Product Change Notification

Product Group: Vishay Passives / CC and NLR / **September 28th, 2026** / **PCN-NLR-013-2026 Rev 0**

Change to completely Pb-free NTC SMD

Pb-free NTC SMD

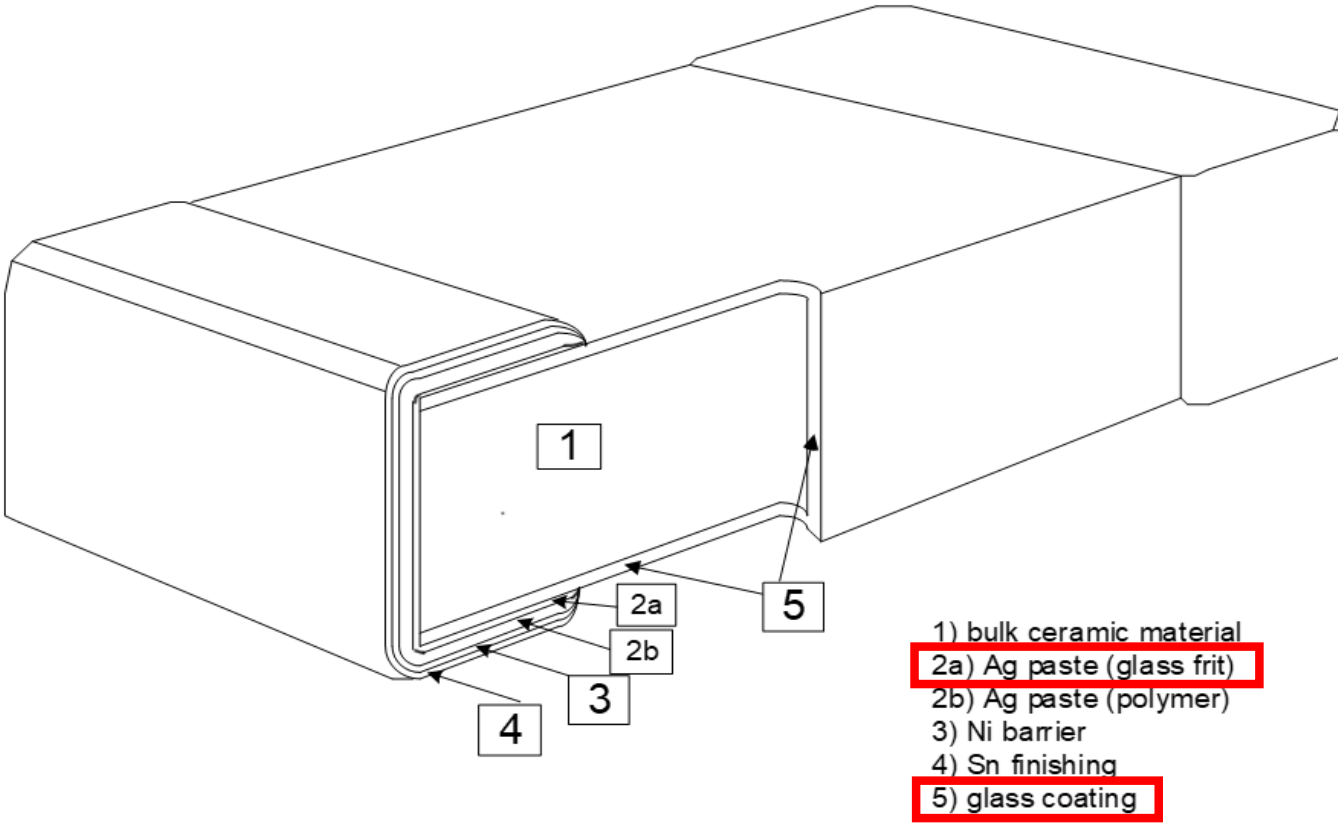
Pb-bearing NTC SMD

Part	Substance	Cas number	weight %
Glass cover (5)	Lead(2+)-silicate	10099-76-0	64%
	Glass without declarable substances	-	36%
Glass Ag Termination (2a)	Silver	7440-22-4	92%
	Lead(2+)-silicate	10099-76-0	5.8%
	Glass without declarable substances	-	2.2%

ROHS Compliant with exemption 7c-I
REACH compliant

Part	Substance
Glass cover (5)	Glass without declarable substances
Glass Ag Termination (2a)	Silver
	Glass without declarable substances

Full ROHS Compliant (no exemptions)
REACH compliant
